The purpose of this notification is to communicate a change in the wafer fabrication and sort facility for XQ18V04VQ44N flash memory configuration PROM device for Aerospace and Defense “XQ” products. There is no change to the fit or function of these devices. The form of these devices is changing with topside marking changes only.

Production of XQ18V04VQ44N with the STMicroelectronics “T7Y” 150nm manufacturing process will transition from the STMicroelectronics M5 wafer fabrication facility in Catania, Italy to the Numonyx Fab2 wafer fabrication facility in Singapore (Table 1).

Figure 1: Sample Marking for Fabrication Change for XQ18V04 Device in VQ44 Package

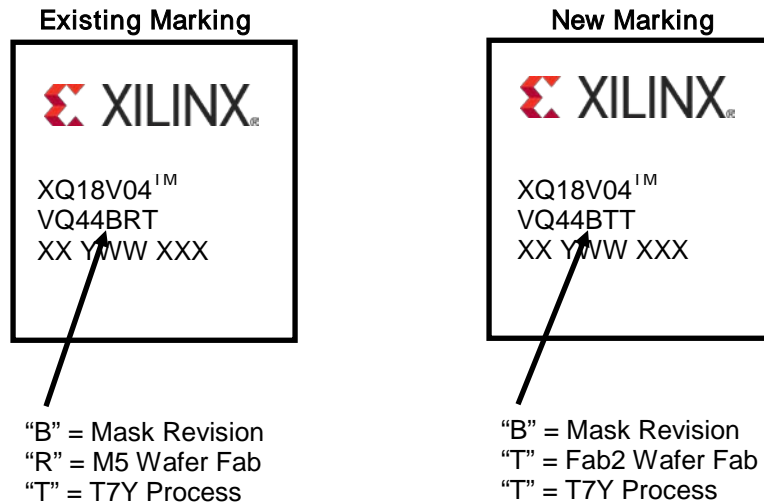
The topside marking will be changed from 'BRT' to 'BTT'. An example is shown in [Figure 1](#) below.
